Staff Report

Site Plan Review

SP-08-23

Site Plan Review application SP-08-23 proposes to construct six apartment units with associated parking and landscaping improvements. The proposed apartment building will be three stories in height and consist of six, two-bedroom apartments.

SITE PLAN

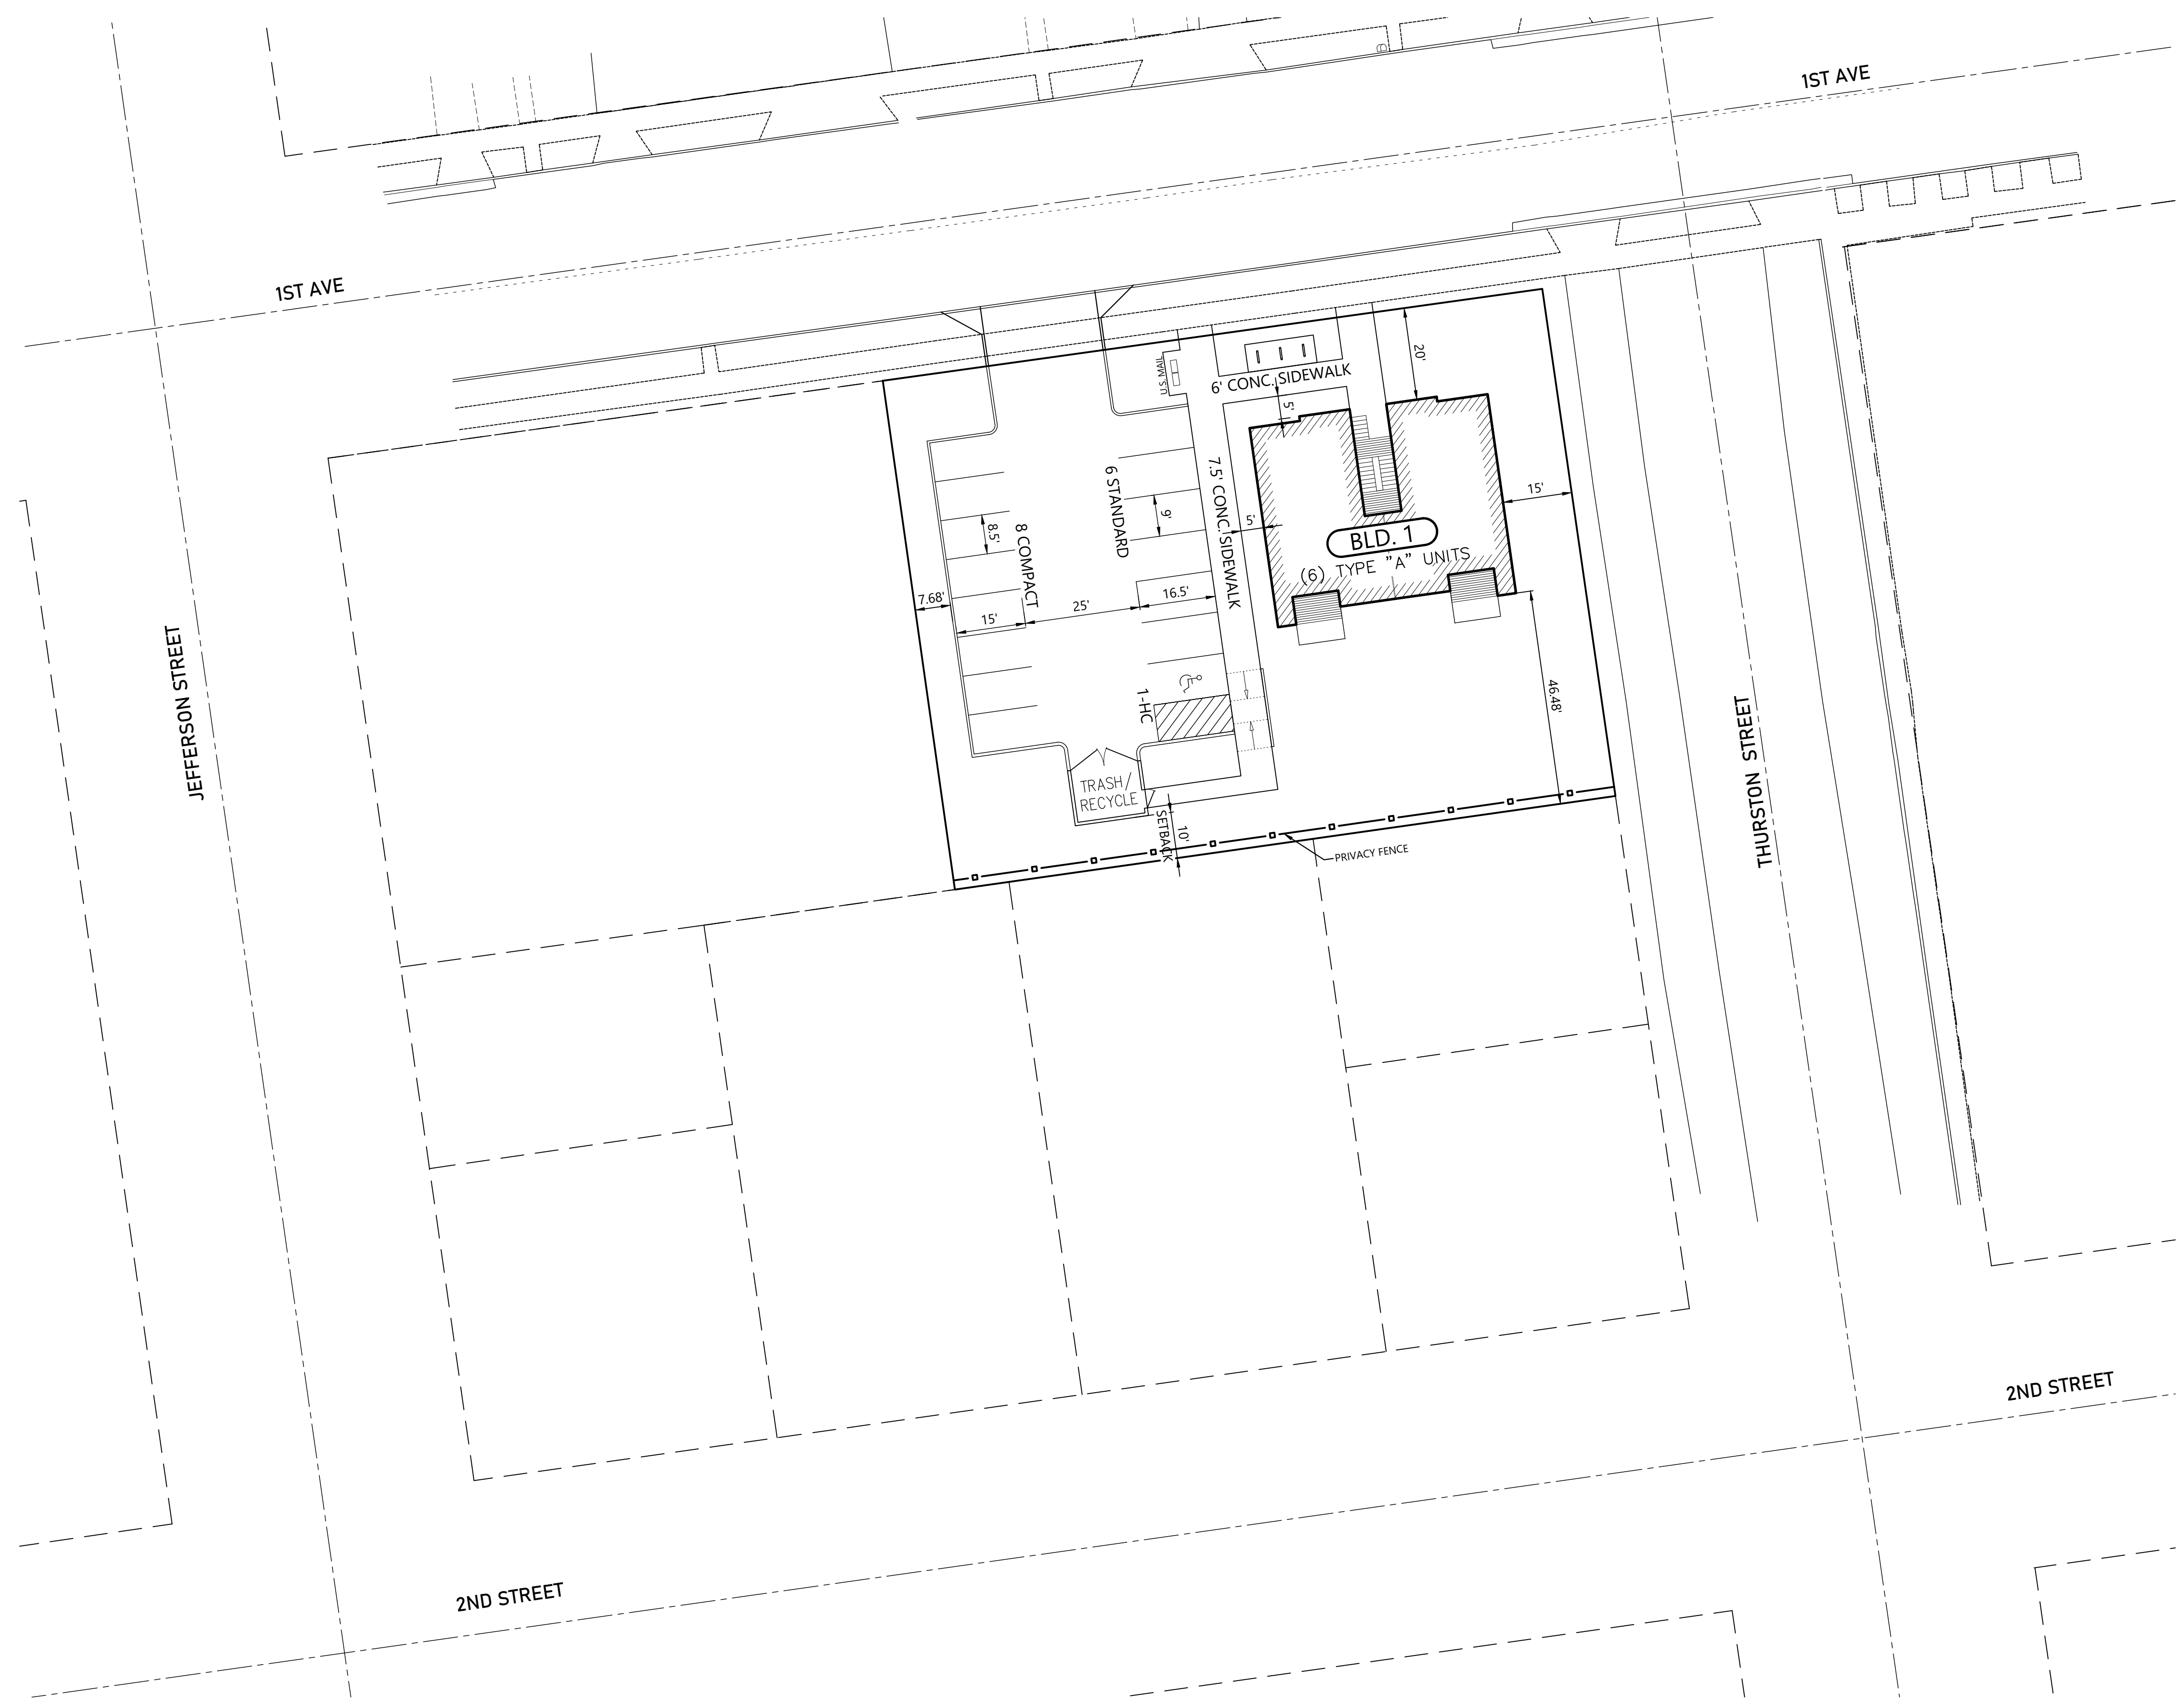
- The proposed parking lot is an accessory use to the multi dwelling unit development. Multi-dwelling unit development abutting a residential zone with an existing dwelling is required to have a 10-foot-wide buffer. Additionally, a multi-dwelling development along an arterial right-of-way requires a 10-foot-wide buffer. The location of the parking lot will be buffered to the north, south, and west, with the apartment building to the east.

- 6.9 ADC 9.120(10) requires conformance with the parking lot landscaping standards found in ADC 9.150. These are discussed in findings below.
- 6.10 ADC 9.120(11) allows up to 40 percent of the required parking stalls to be compact, which would allow for a maximum of six compact spaces. The submitted site plan (Attachment B) indicates a total of eight compact parking spaces with a depth of 15 feet and a width of eight feet and six inches wide. Table 9.130-1 indicates the minimum stall width for compact spaces is eight feet in width and 16 feet in depth. Additionally, all compact spaces must be signed and/or the space painted with the words "Compact Car Only". As proposed, the parking stalls do not meet this parking standard. Prior to the issuance of building permits, the applicant shall submit a revised parking plan detailing conformation to standards in ADC 9.130.

The proposed parking stalls and aisle width are not compliant with the parking lot design standards of ADC 9.130. As a condition of approval, the applicant shall provide an updated parking plan showing compliance with the standards of ADC 9.130 prior to the issuance of a building permit.

Preliminary Plant Schedule

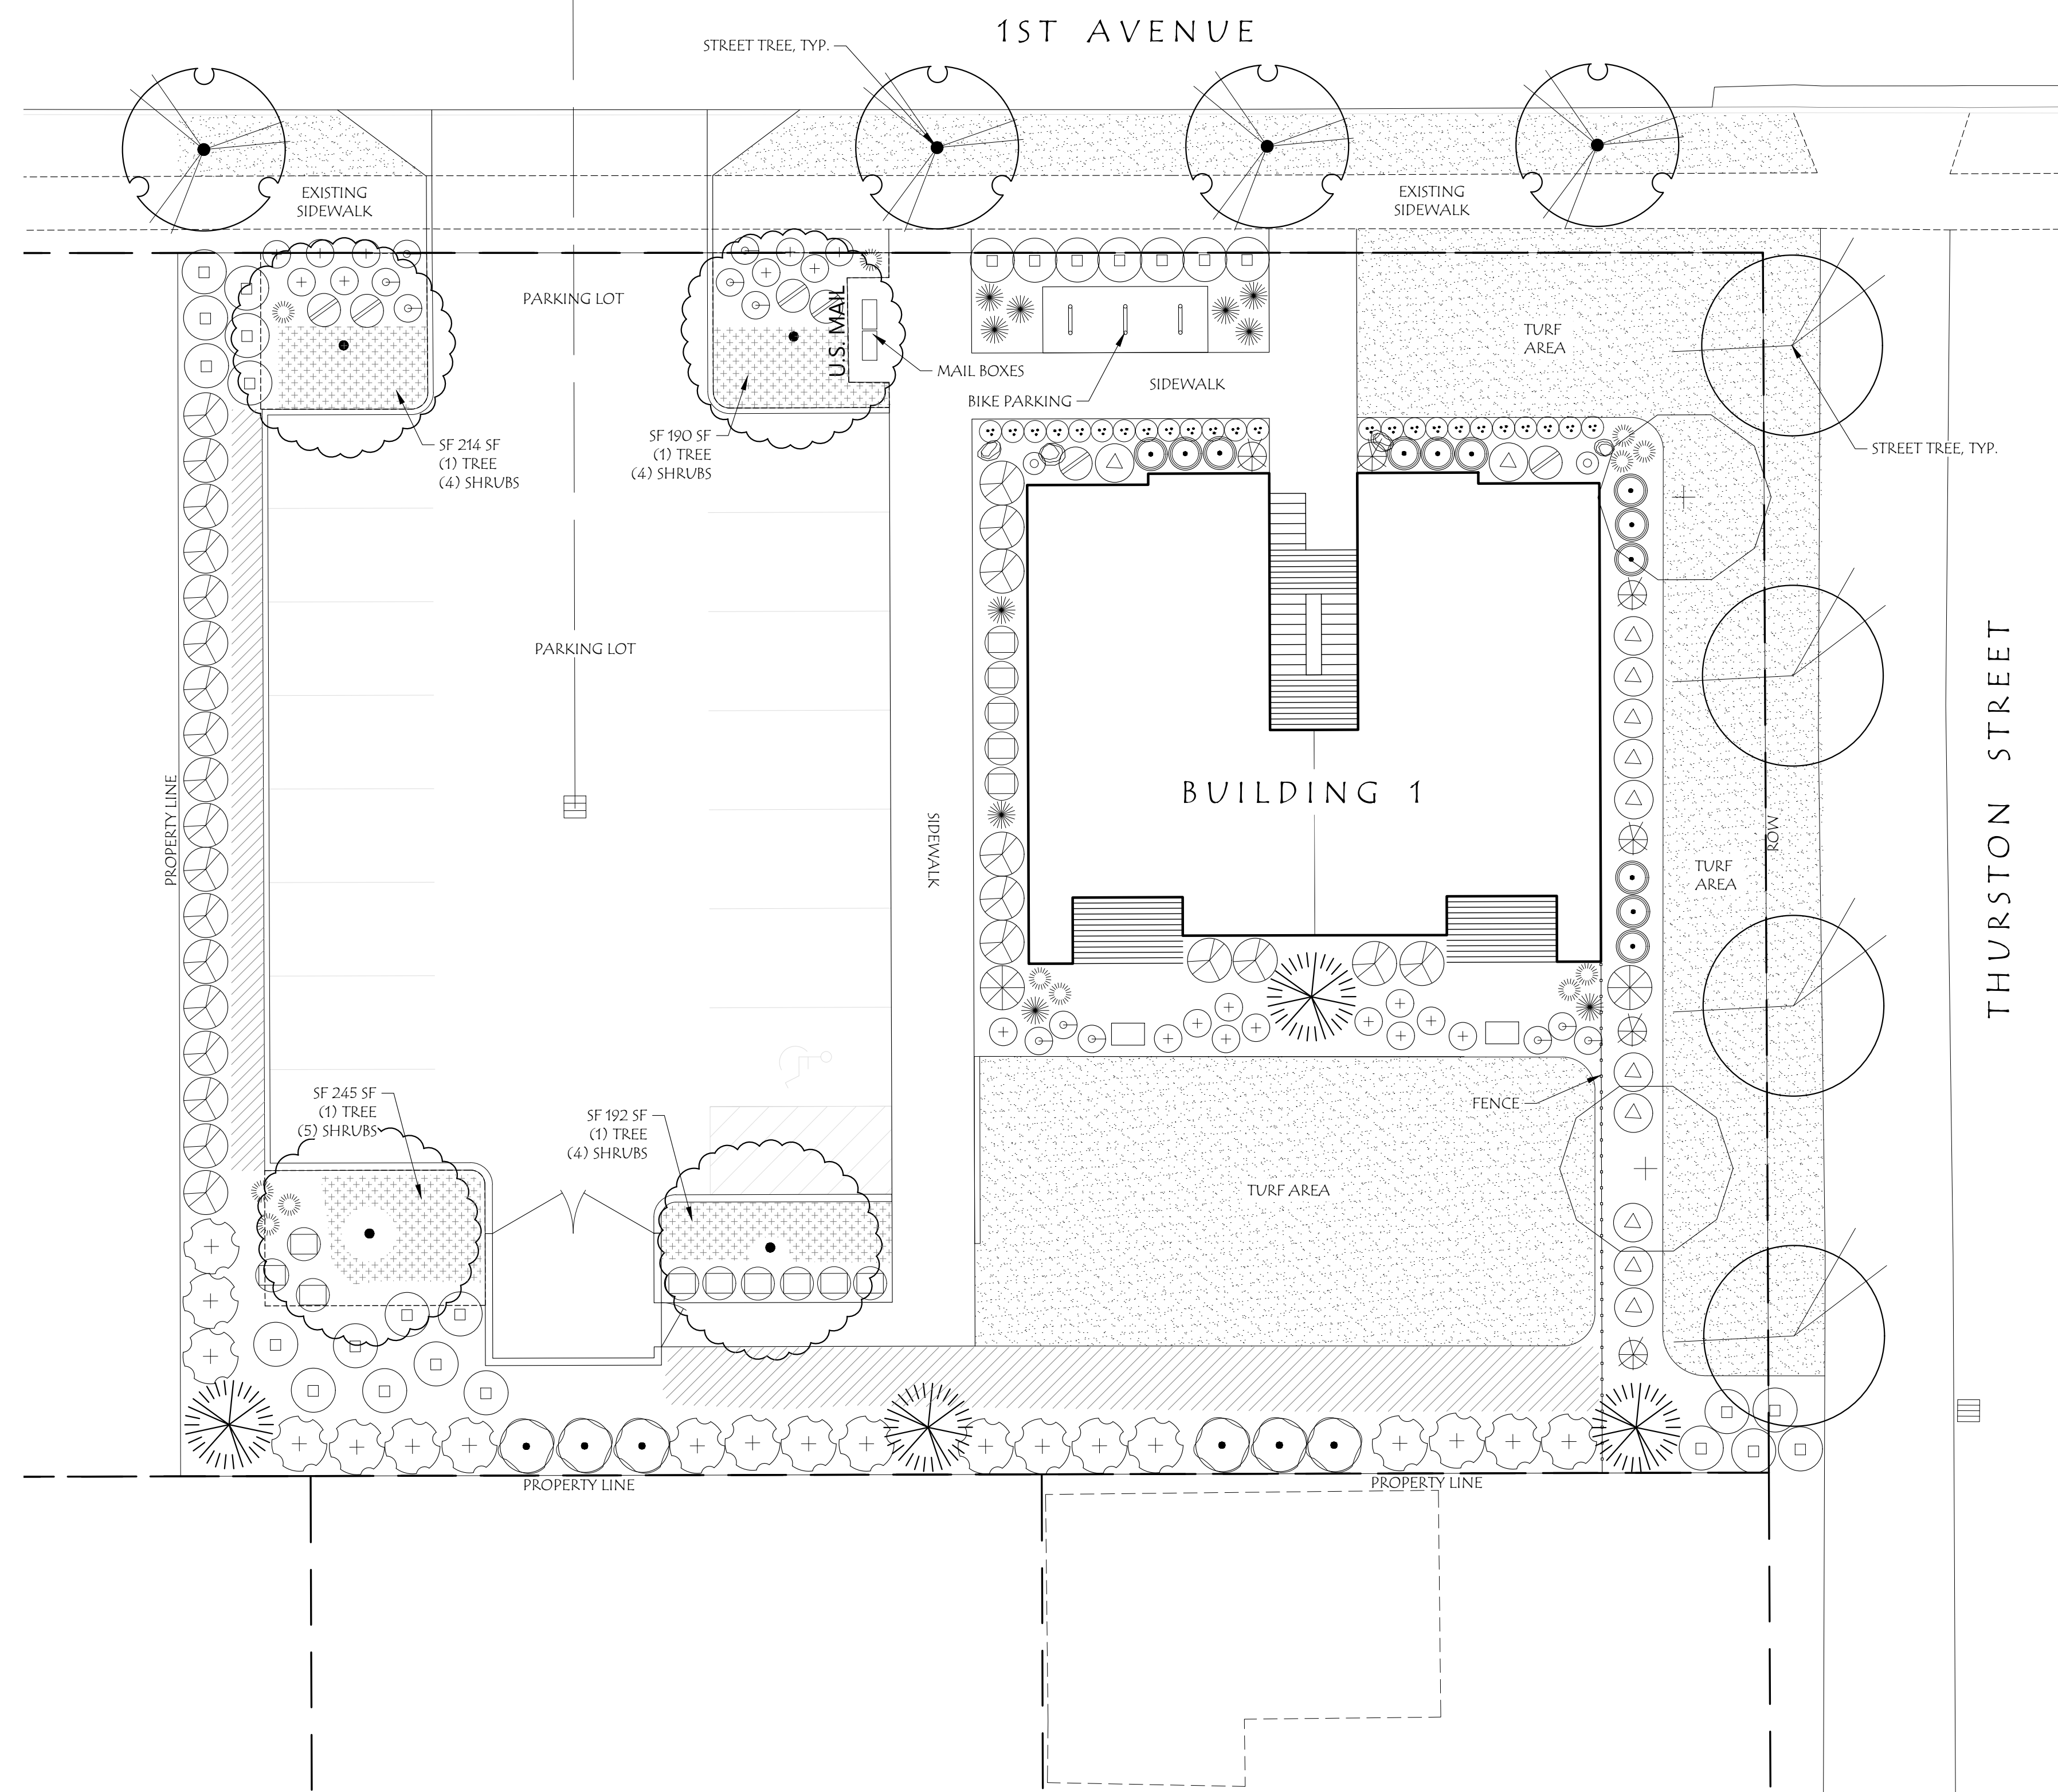
The applicant's preliminary landscaping plan indicates the number, size, and type of vegetated material proposed. The preliminary landscaping plan (Attachment E) is not compliant with the required landscaped buffering standard. As shown on the site plan, the site design will accommodate the required landscaping buffer; however, prior to issuance of any building occupancy, the applicant will need to submit a landscaping and irrigation plan for review and approval.

Condition 5 Landscaping and Irrigation System. Before the City will issue any certificate of occupancy for the proposed structure(s), the applicant shall provide a landscape plan and either an irrigation plan or a letter from a qualified landscape professional stating irrigation is not required per ADC 9.160.
